Subject: Minutes for 56th Protection Sub-Committee Meeting.

56th Protection Sub-Committee Meeting (20th January, 2025)-MoM

**Minutes of
56th Meeting of Protection Sub-Committee (PSC) of
Northern Regional Power Committee**

DR of 30 MW Khodri - UNIT 2

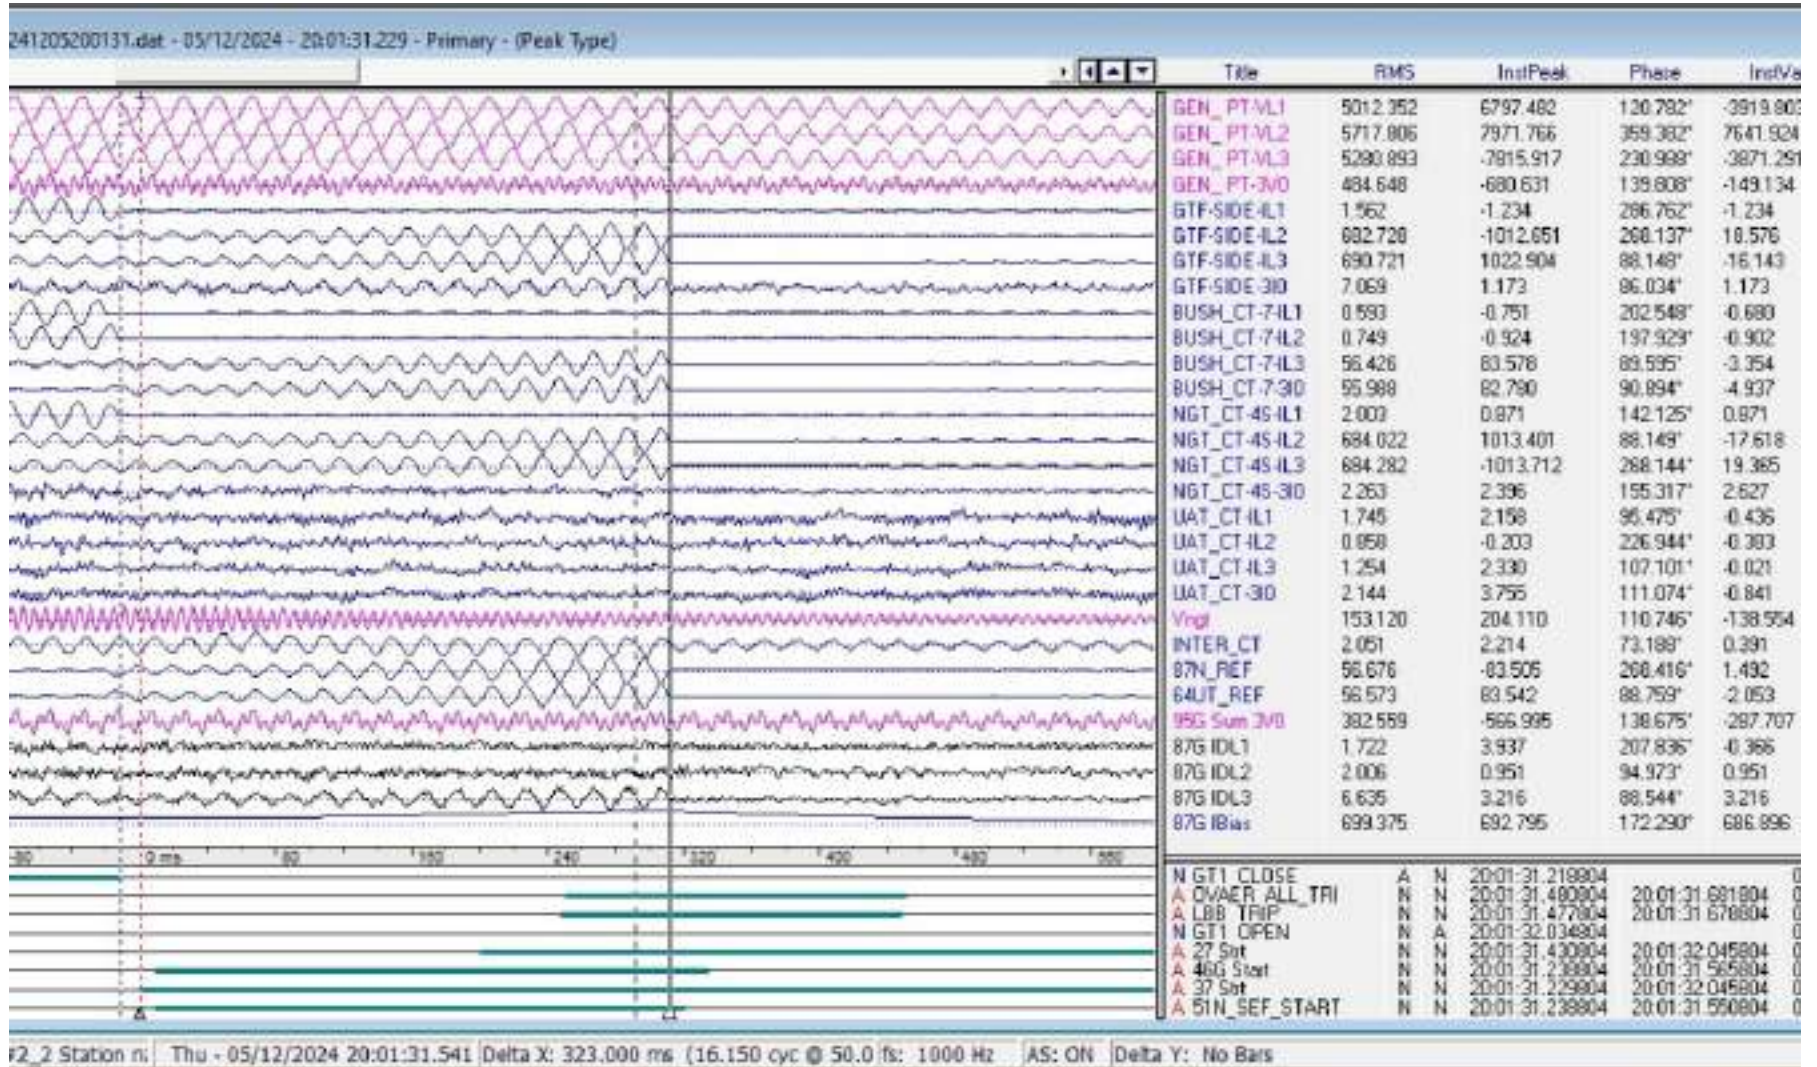
✓ LBB Protection Operated

DR of 30 MW Khodri - UNIT 2

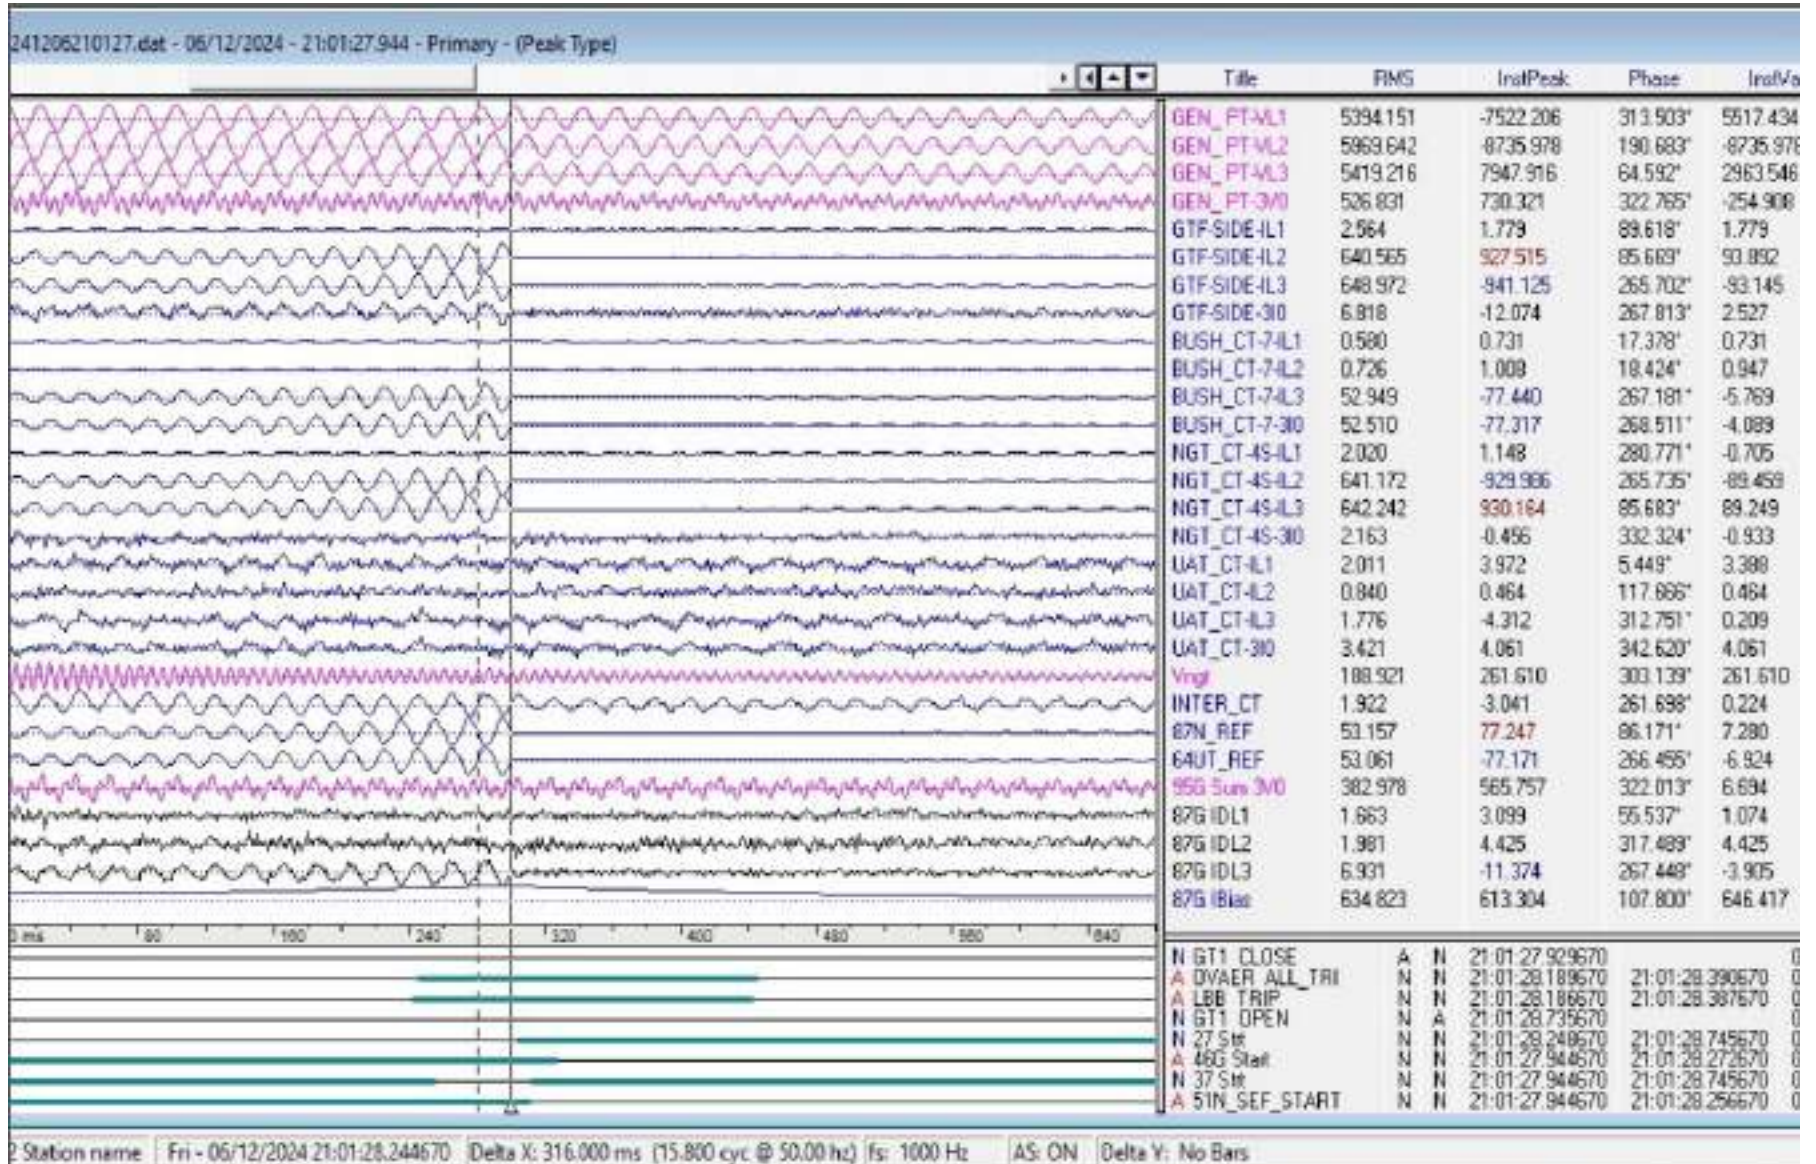
✓ LBB protection operated

DR of 400kV Gorakhpur(PG)(end)-Basti line-1

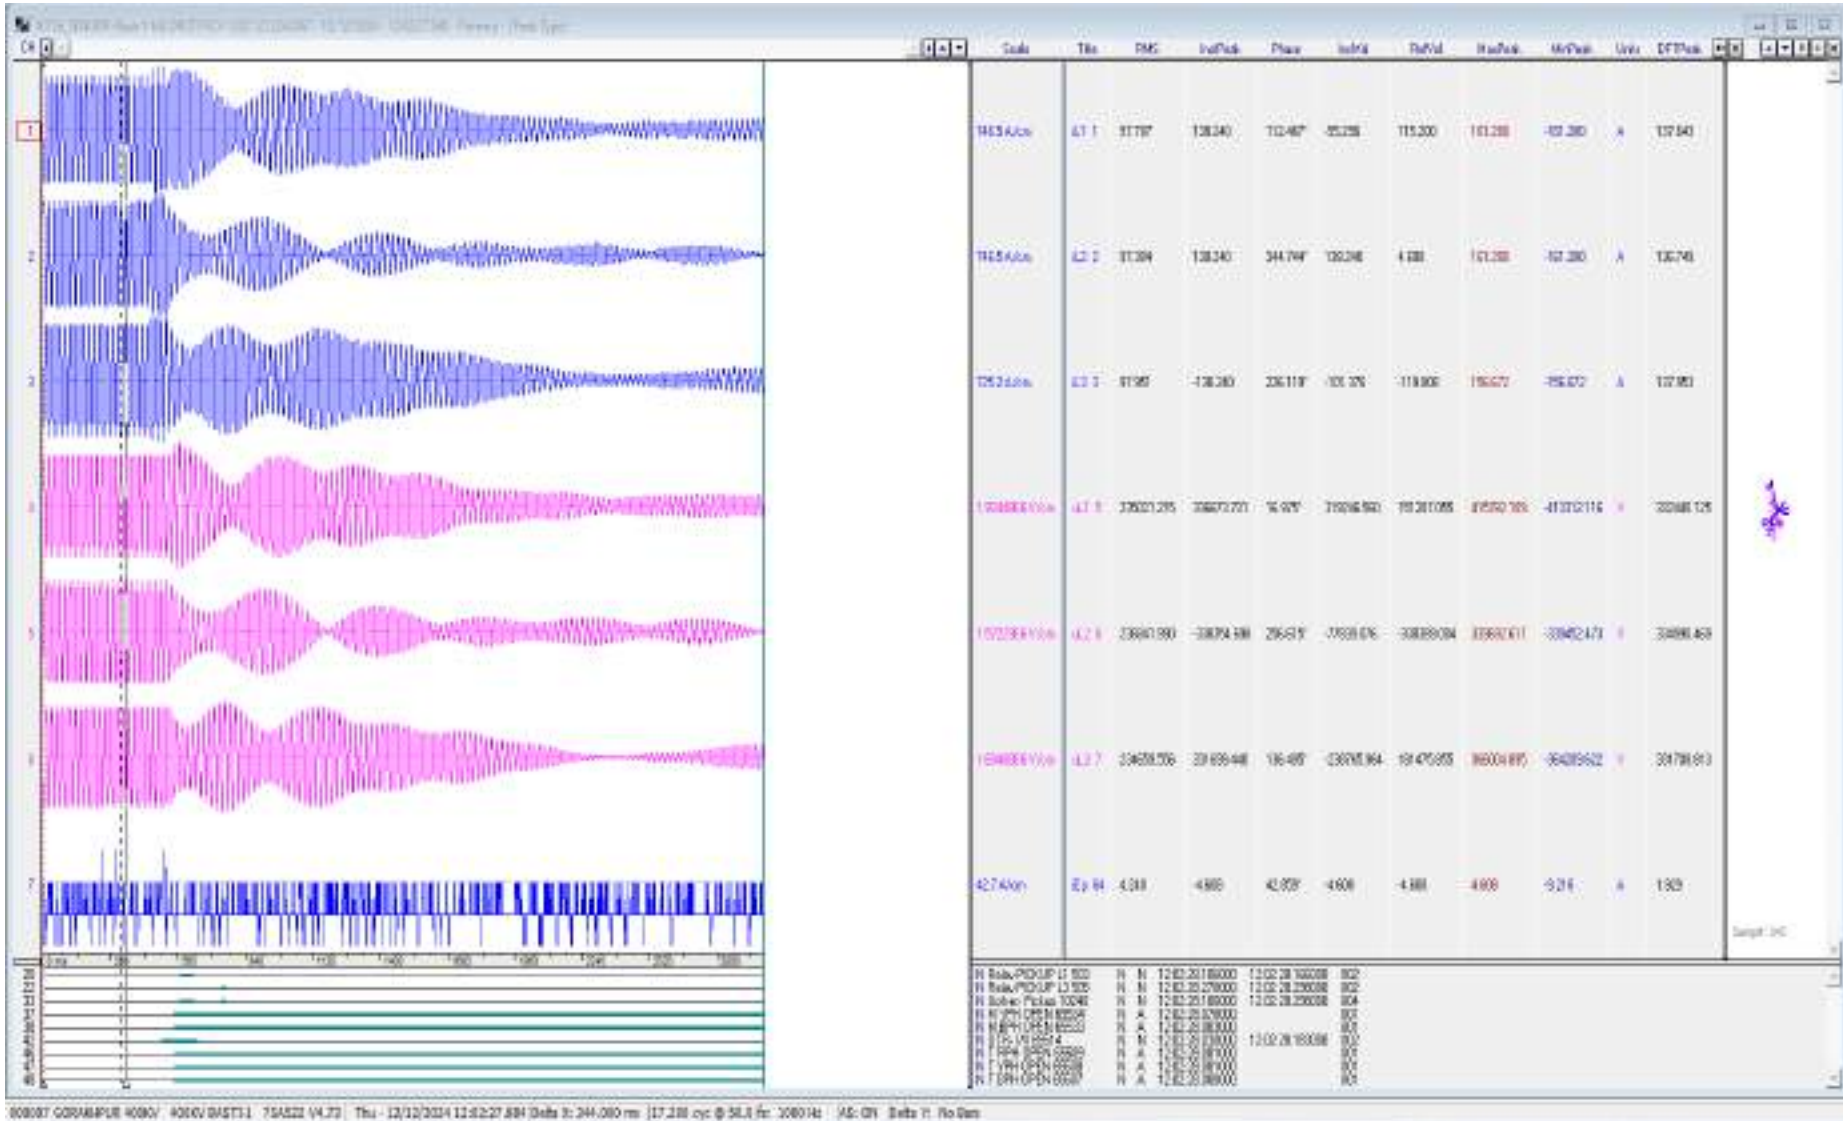
No fault in system, DT received at Gorakhpur end

DR of 400/220kV 315MVA ICT-1 at Bikaner(RS)

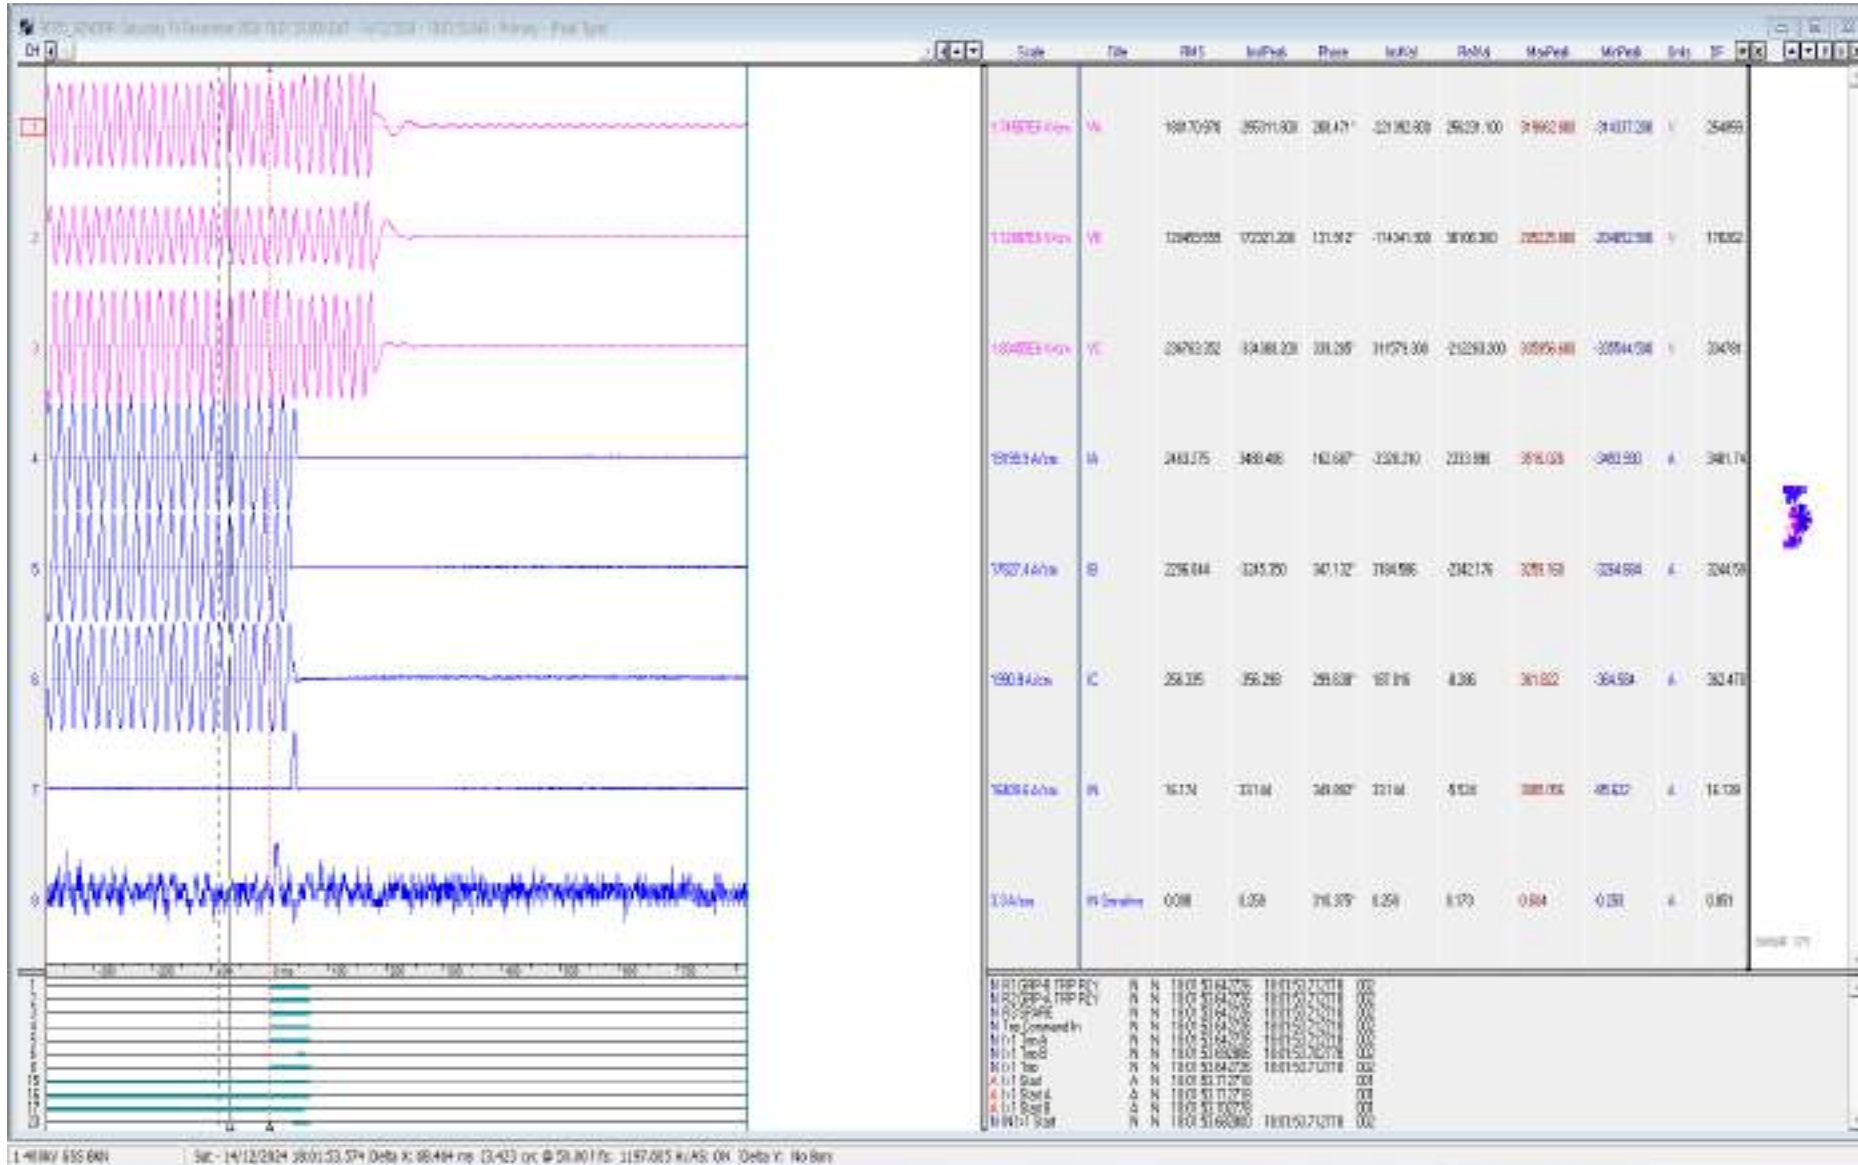
R-Y fault, 2.4kA, O/C E/F operated, Time not synced

DR of 220kV Tanakpur-CB Ganj(end) ckt

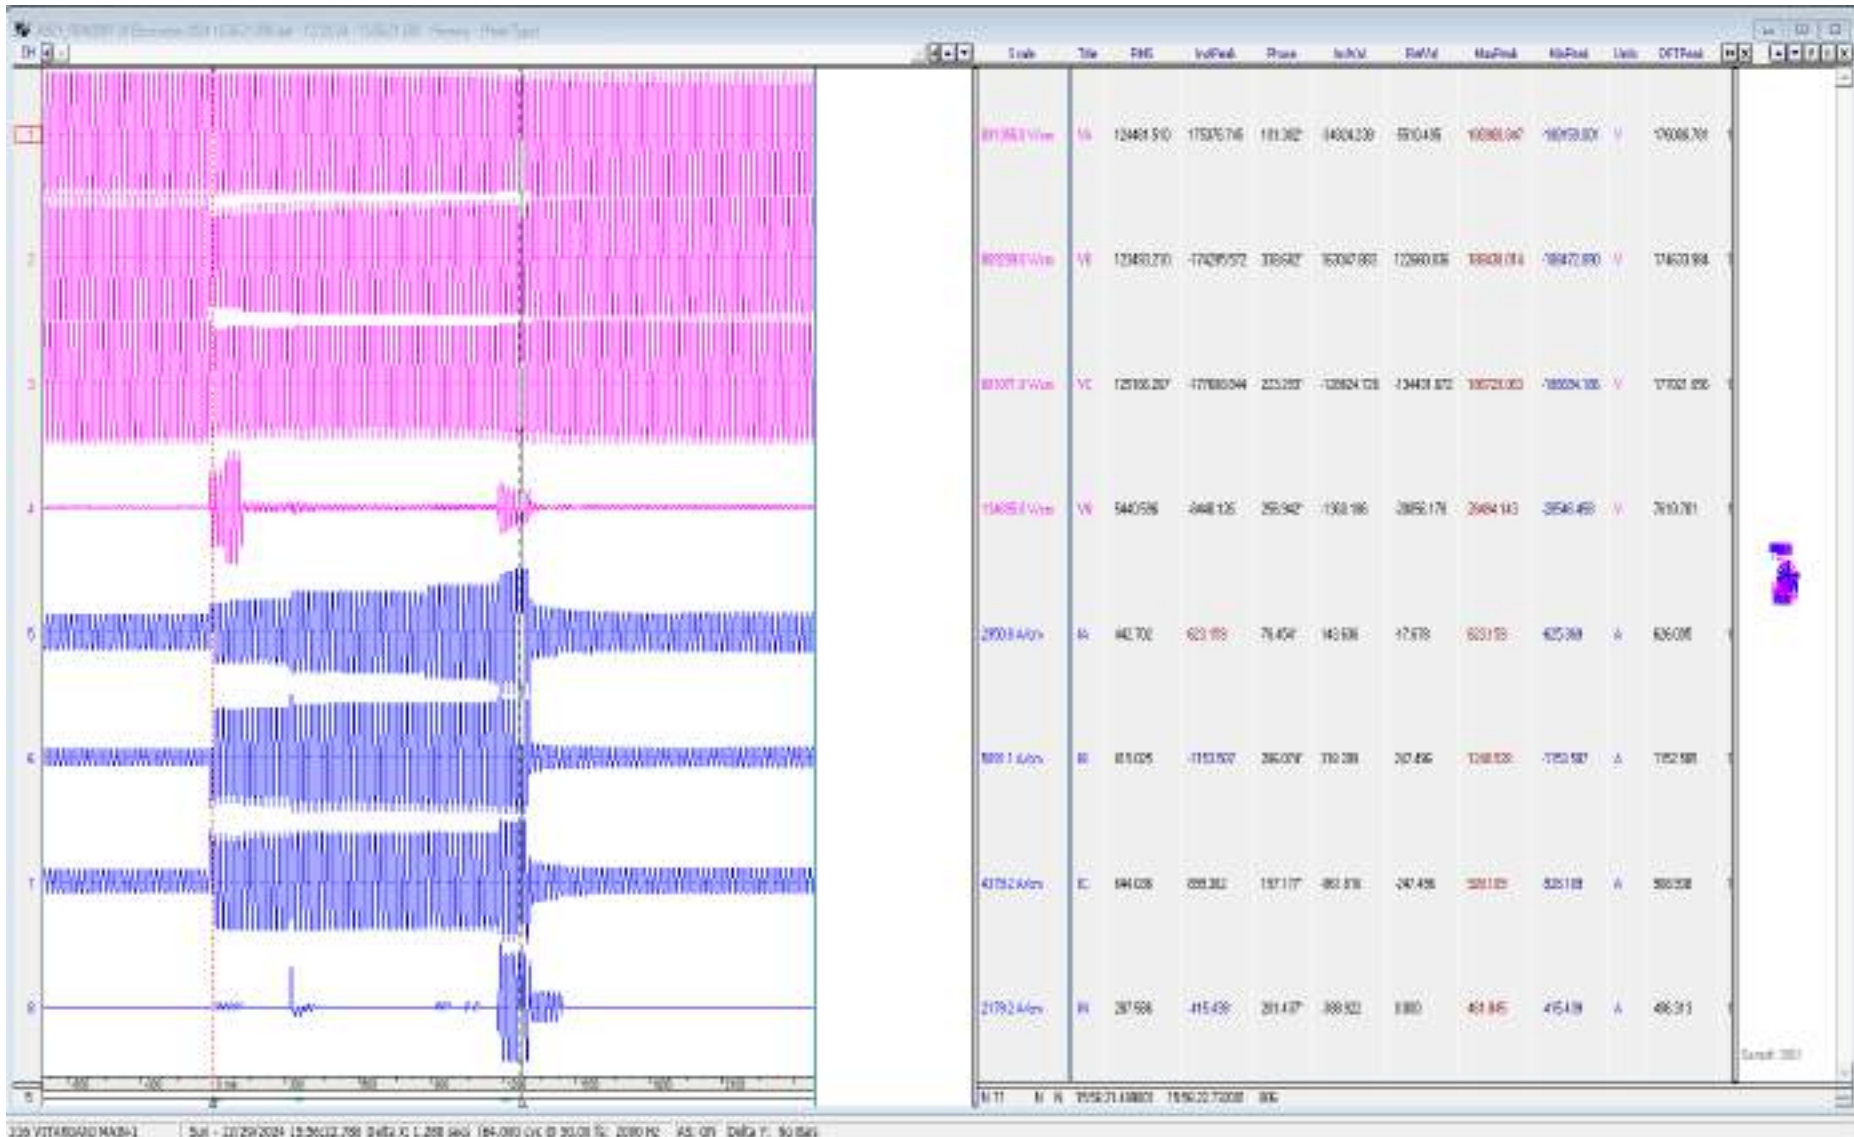
Fault clearance time: ~1280msec; Y-N fault was sensed by Main-2 relay. Line didn't trip
